**AMD-K6™**

**MMX™ Enhanced Processor**

**Revision Guide**

# AMD-K6™ MMX™ Enhanced Processor Revision Guide

**Figure 1. AMD-K6 Processor Assertion of HLDA Due to Simultaneous  $\overline{\text{BOFF}}$ /HOLD Assertion**

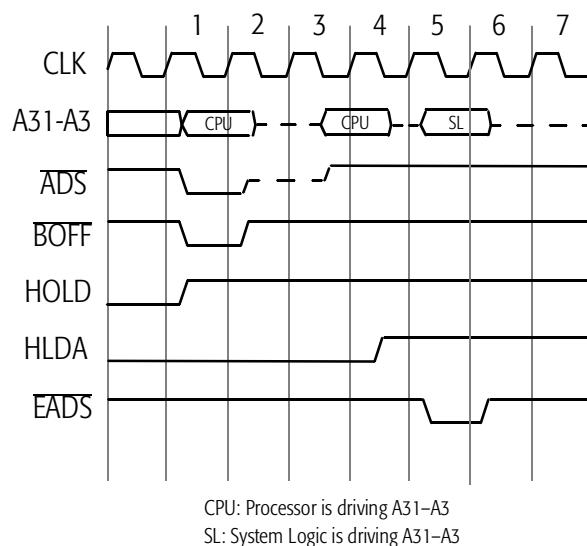
**Normal Specified Operation.** If  $\overline{\text{BOFF}}$  and HOLD are sampled asserted on the same clock edge that negates  $\overline{\text{ADS}}$ , the processor asserts HLDA one clock edge after HOLD is sampled asserted.

**Non-conformance.** If  $\overline{\text{BOFF}}$  and HOLD are sampled asserted on the same clock edge that negates  $\overline{\text{ADS}}$ , the processor asserts HLDA two clock edges after HOLD is sampled asserted.

**Potential Effect on System.** There are three potential effects of this erratum to consider:

- If the system logic asserts  $\overline{\text{BOFF}}$  for a duration of one clock, anticipates the assertion of HLDA in clock 3 (see Figure 1)—which is the normal specified operation—and drives the address bus and  $\overline{\text{EADS}}$  for an inquire cycle in clock 3, then the processor will not sample  $\overline{\text{EADS}}$  asserted. In addition, address bus contention will occur in clock 3.

- If the system logic asserts  $\overline{\text{BOFF}}$  for a duration of two clocks, anticipates the assertion of HLDA in clock 3, and drives the address bus and  $\overline{\text{EADS}}$  for an inquire cycle in clock 3, then the processor will not sample  $\overline{\text{EADS}}$  asserted. (No address bus contention occurs in this case.)

- If the system logic asserts  $\overline{\text{BOFF}}$  for a duration of one clock, anticipates the assertion of HLDA in clock 3, and drives the address bus and  $\overline{\text{EADS}}$  for an inquire cycle in clock 4, then address bus contention may occur in clock 4. (The processor will sample  $\overline{\text{EADS}}$  asserted in this case.)

If the processor does not sample  $\overline{\text{EADS}}$  asserted during an inquire cycle, cache/memory incoherency will occur. Address bus contention can affect the reliability of the processor and the system logic.

**Suggested Workaround.** The system logic must sample the assertion of HLDA before asserting  $\overline{\text{EADS}}$  and driving the address bus for an inquire cycle—as shown in clock 5 of Figure 1.
